**SAN ANTONIO WATER SYSTEM  
EAST SIDE SERVICE CENTER  
ODOR CONTROL &  
RECYCLED WATER FILLING STATION  
SAWS JOB NUMBERS: 11-8605-202 & 11-2516  
SOLICITATION NUMBER: B-11-014-DG  
ADDENDUM NO. 1**

**March 21, 2011**

The purpose of this addendum is to issue a revision of the plans and contract documents for the East Side Service Center Odor Control and Recycled Water Filling Station, SAWS job numbers: 11-8605-202 and 11-2516.

MAP No. XXX-XXX SHEET C-5  
 SECT. No. II-8605-202  
 DR. MJM CK. ETM JOB No. & II-2516 OF 15

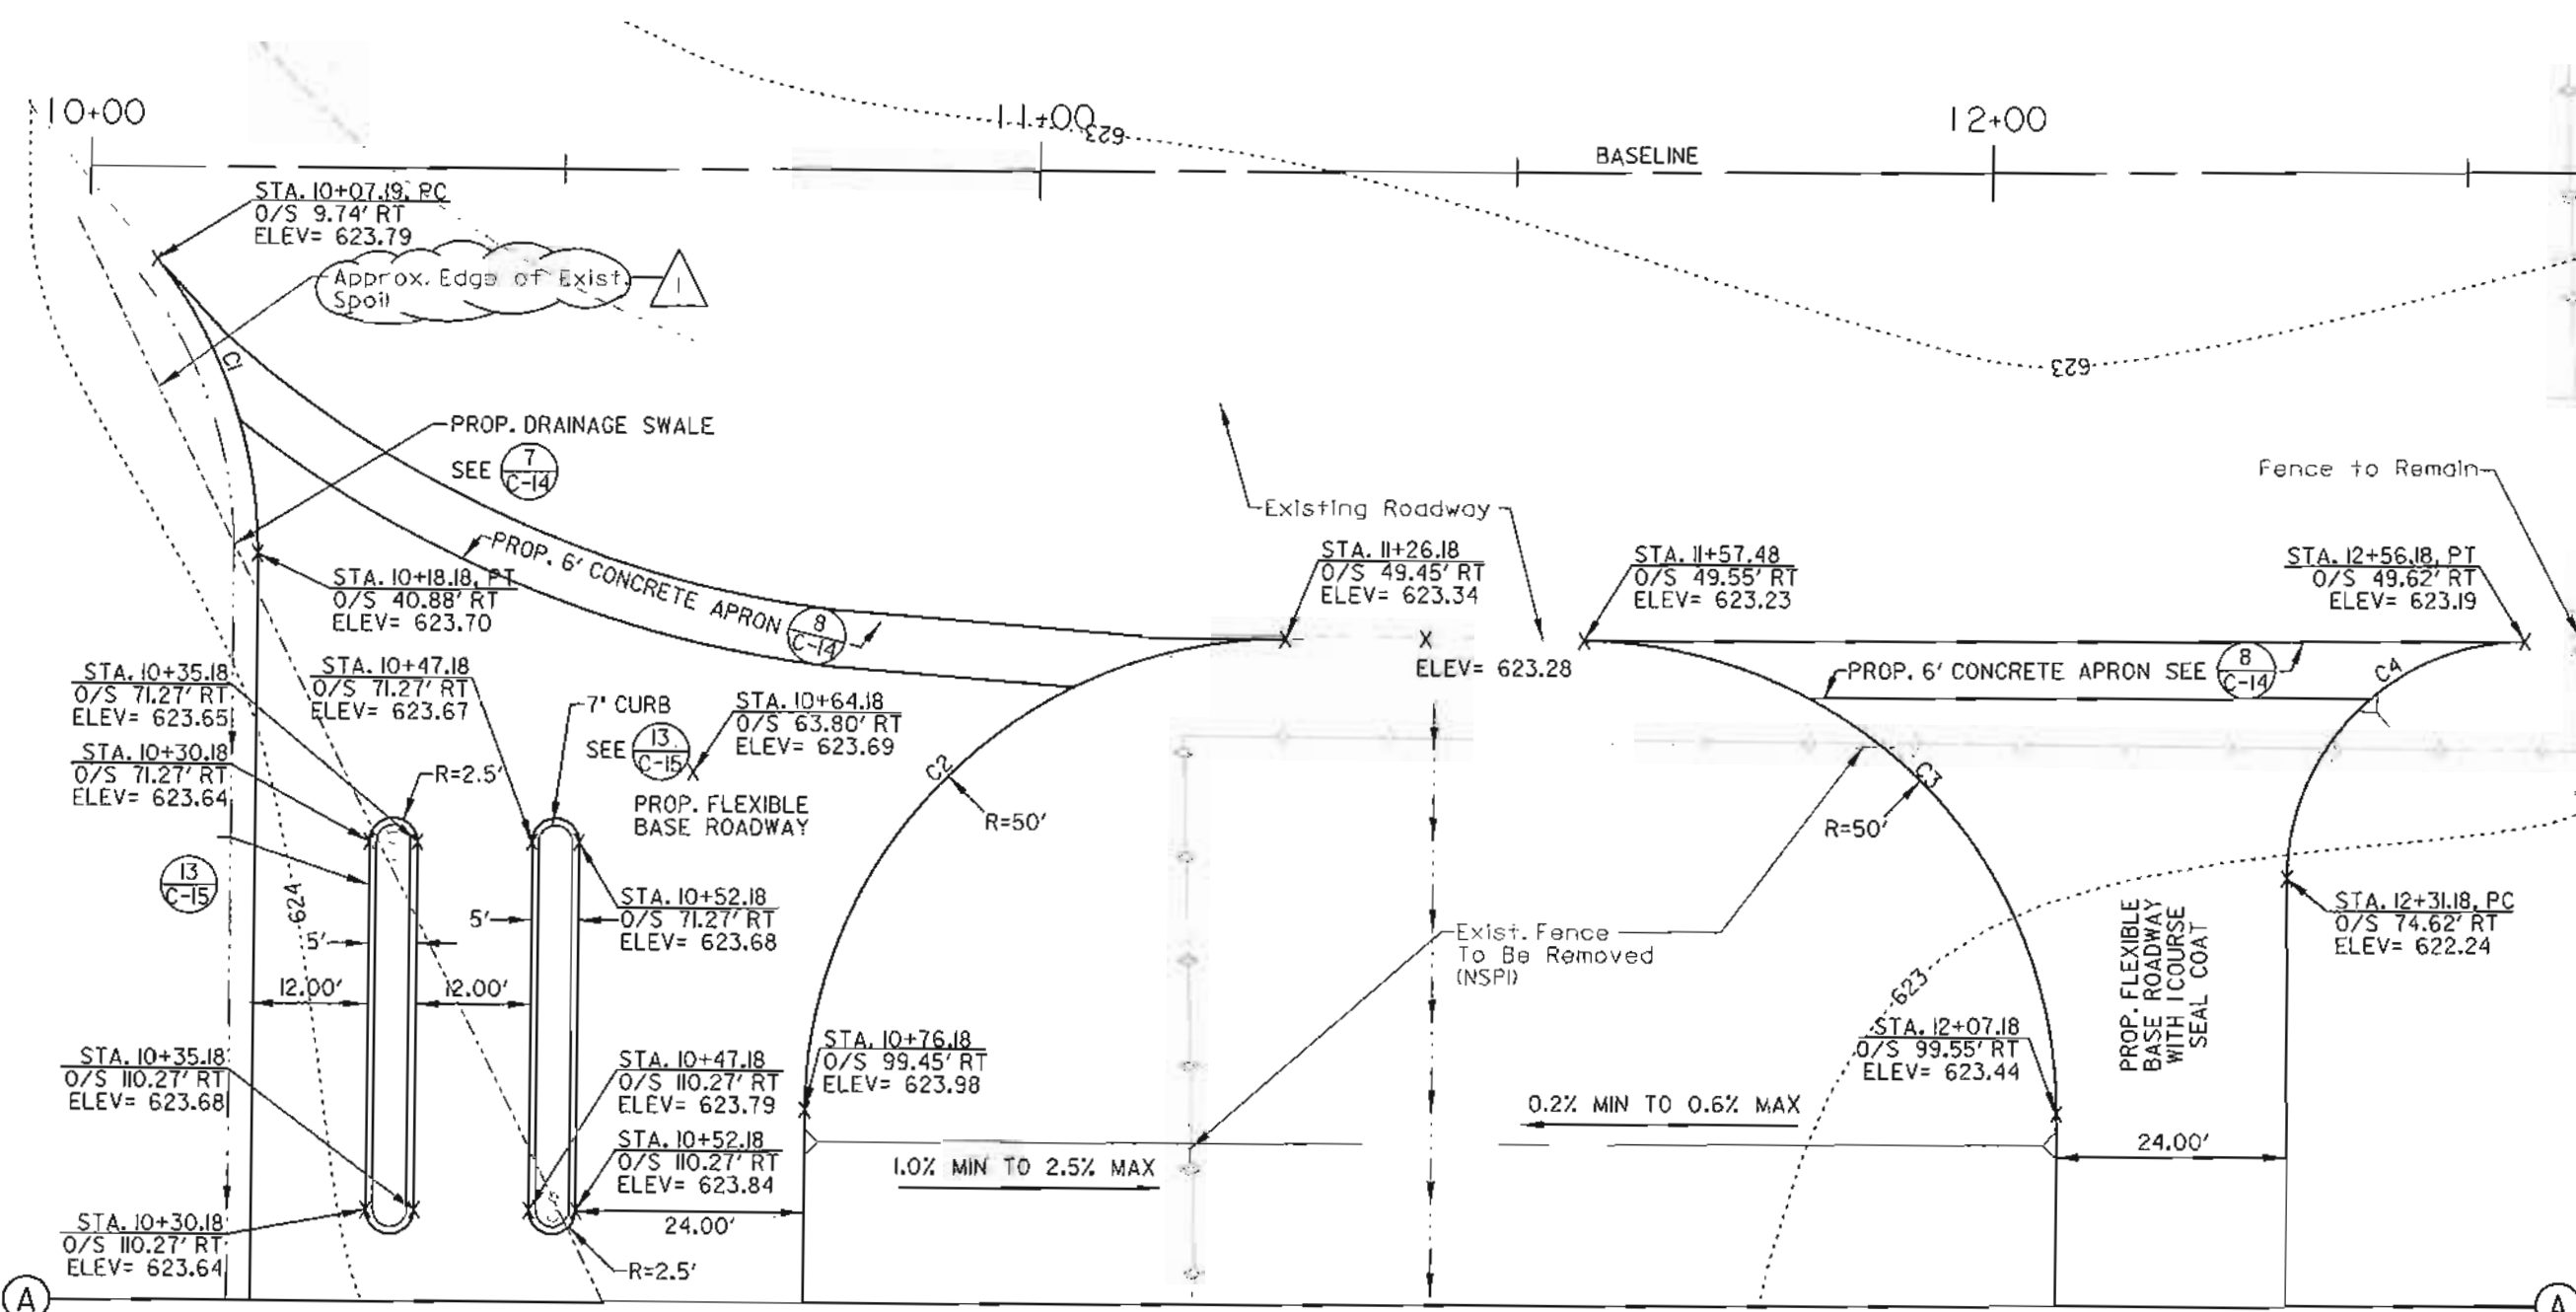
- On sheets C-5, C-8, C-10, C-11 and E-2, the 4" potable waterline has been increased in size to a 6" line.
  - On sheet C-8, all pipe fittings, connections, valves, etc. associated with the 4" waterline have been changed to reflect the increase in waterline size.

- On sheets C-5, C-6 and C-7, the limits of the existing spoil material have been updated.
  - On sheet C-9 five additional reaction blocks have been added to the recycled waterline near the fire hydrants.

4 SHOWER CONNECTION  
DETAIL  
NOT TO SCALE

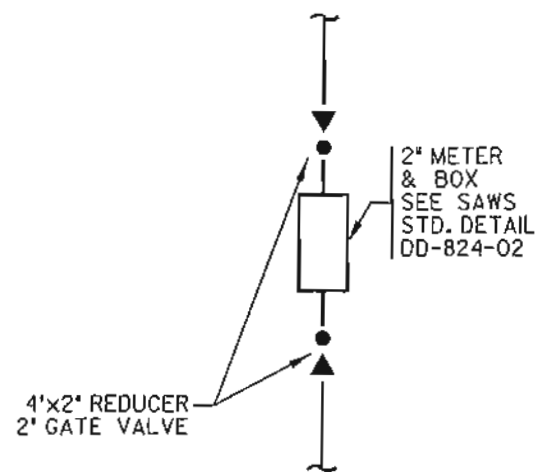
- On sheet C-13, the shower connection detail has been revised to show that insulation will be provided on the 2" waterline servicing the odor control facility.

NOTES: 1. 2" PVC WATERLINE SHALL BE ATTACHED TO WALL AS PER SAWS INSTRUCTIONS  
2. 2" PVC WATERLINE SHALL BE INSULATED AS PER SAWS INSTRUCTIONS N.S.P.I.

NOTE: PROVIDE ONE 4" CAP ON EACH END OF EACH 4" PVC CONDUIT.  
12 4" PVC CONDUIT END DETAIL  
NOT TO SCALE

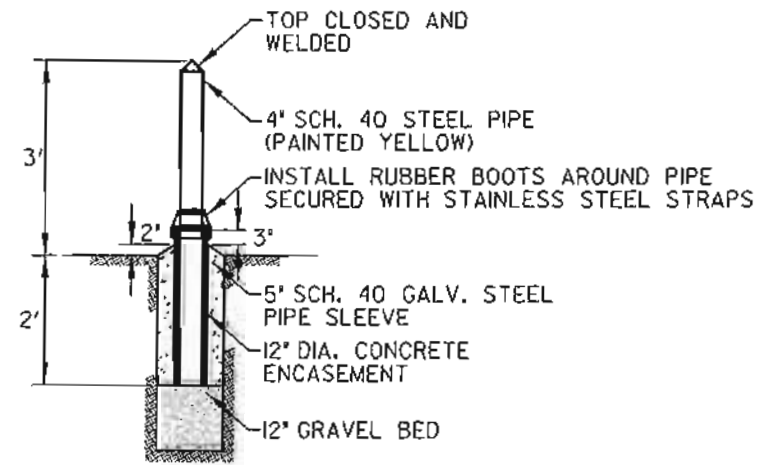
- On sheet C-15, the 4" PVC conduit end detail has been updated for clarity.
  - On sheet E-2, note 1 has been revised to include an approximate distance from the existing power panel near the concrete mixer to the proposed power panel "A"

**ELECTRICAL SITE PLAN**  
SHT. 17 OF 25

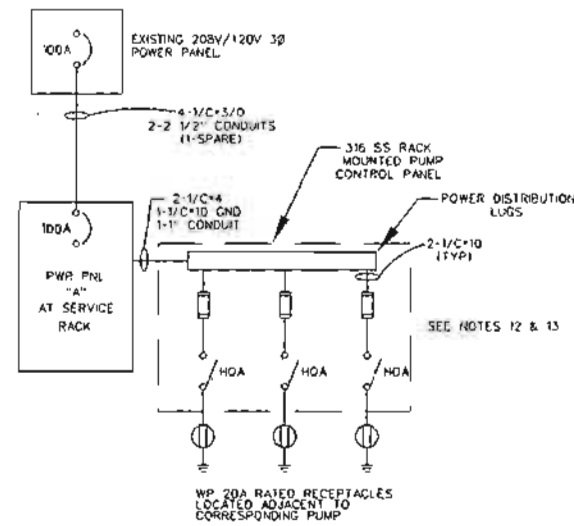
- On sheet E-2, note 2 has been revised to read "Above ground conduit shall be rigid aluminum."
  - On sheet E-5, Detail A has been revised.
  - On sheet E-6, Detail A has been revised to call for a ¾" Aluminum conduit, not a ¾" PVC coated galvanized steel conduit.

- NOTES:
1. DUCT BANK SHALL EXTEND FROM EXISTING POWER PANEL LOCATED ADJACENT TO CONCRETE MIXER TO PROPOSED POWER PANEL 'A' (APPROXIMATELY 600 FT.)
  2. FOR ADDITIONAL CONDUIT SIZES AND ROUTING, REFER TO SHEET E-3.

**B** POWER PANEL "A" SCHEDULE  
SCALE: N.T.S.

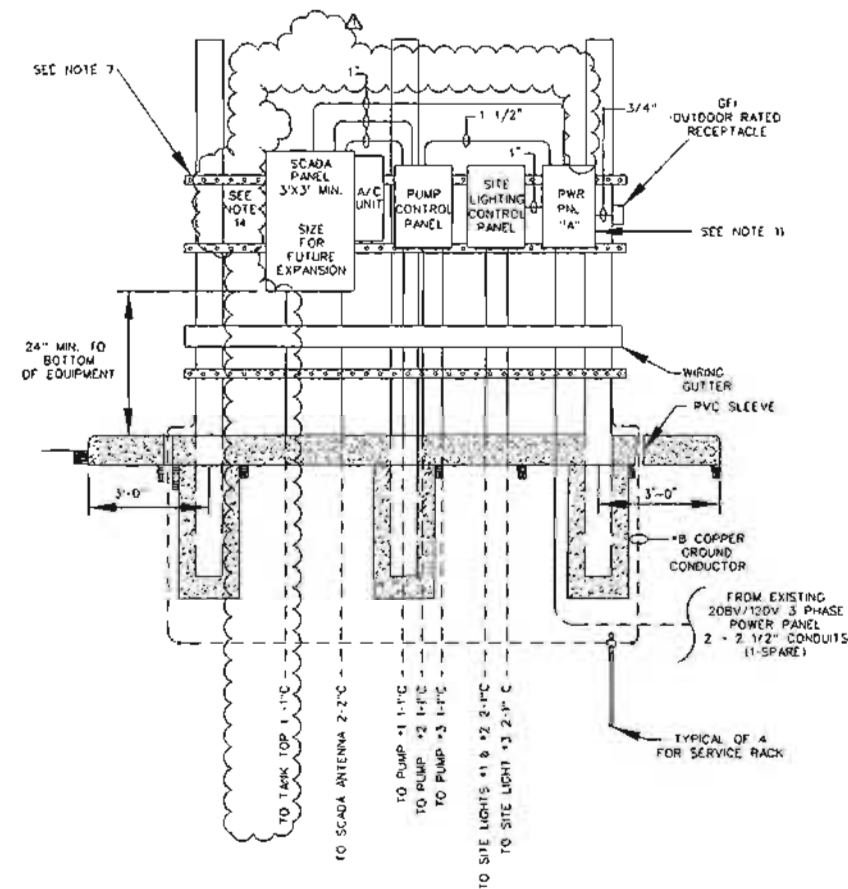
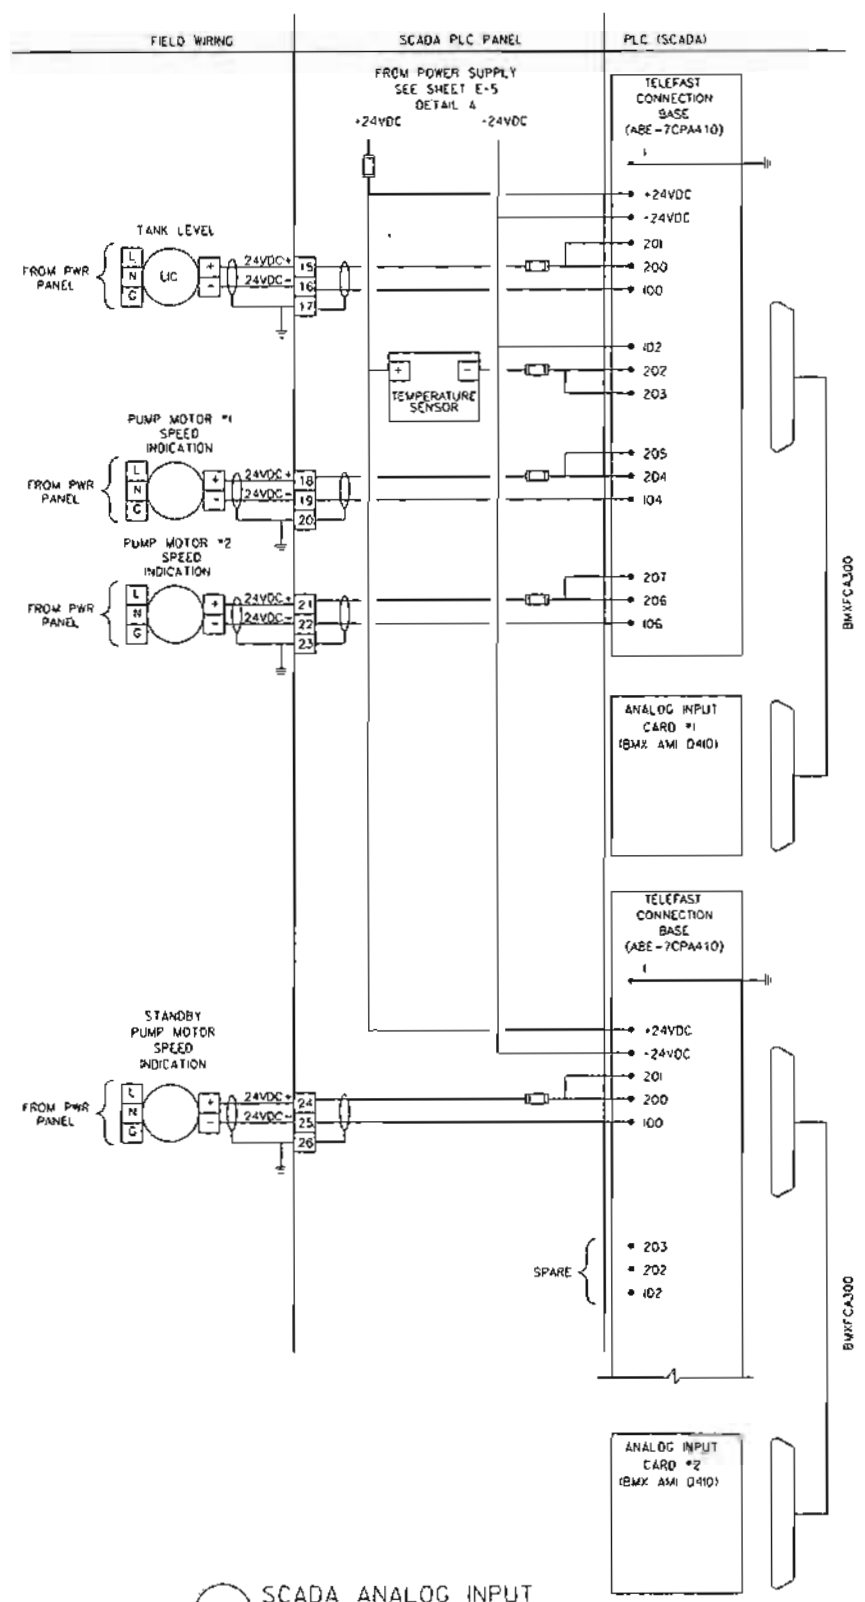
- On sheet E-3, the voltage of the 100 A main breaker has been updated to 208V/120V.
  - On sheet E-3, note 14 has been added. This note references Detail B and Detail C.

**A** SIDE VIEW SCADA ANTENNA POST & FOUNDATION  
SCALE: N.T.S.

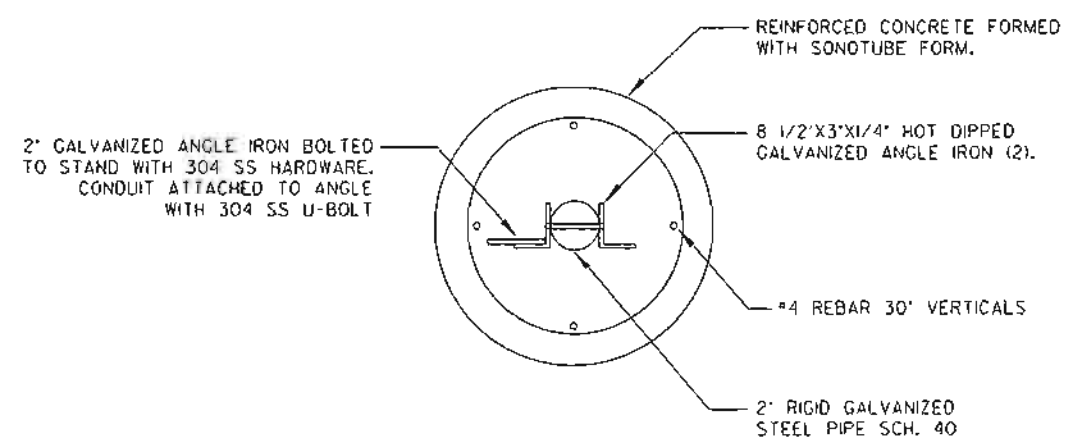
- On sheet E-6, Detail C has been revised.
  - On sheet E-6, Detail D has been revised to call for a two position selector switch which has 2 contact blocks to open the circuit when in the "off" position.
